RR/2018/545/P: BP Filling Station. Udimore Road - Land North of Rye TN31 6AA Construction of petrol filling station, canopy, sales building, ATM, AC/refrigeration units, refuse compound, parking and associated works

The Rye Conservation Society wishes to object to the revised application. The single issue to be considered in respect of the revised planning application for a BP Filling Station and Shop is whether the changes made as part of the current application are sufficient to overcome the two reasons given by Rother for their refusal of the first application.

# BP Filling Station: Long Distance views of site. LV2

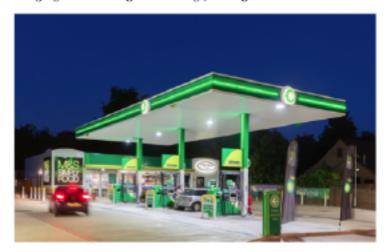
- 3. Because of the elevated site located on this prominent ridge, many of the long views to the site are from below and therefore look up. This means that the three 4m lighting standards and the canopy lighting at 4.3m will be highly visible from the surrounding countryside within the AONB and from Rye. Although the height of a number of the lights has been reduced, and those specified chosen to reduce light leakage, the site is still going to be a lit element within a dark countryside area.
  - See attached Long Views Sheets 1-3.
  - See also the comments regarding the visual effect on the AONB landscape contained in our objections to the previous scheme, amended as required to note the recent changes.
- 4. The hours of opening remain 24 hours a day, seven days a week and the effect on the AONB and the local residents would be the same as for the first application.

#### This is not correct as is shown by their own photographs in the LVIA.
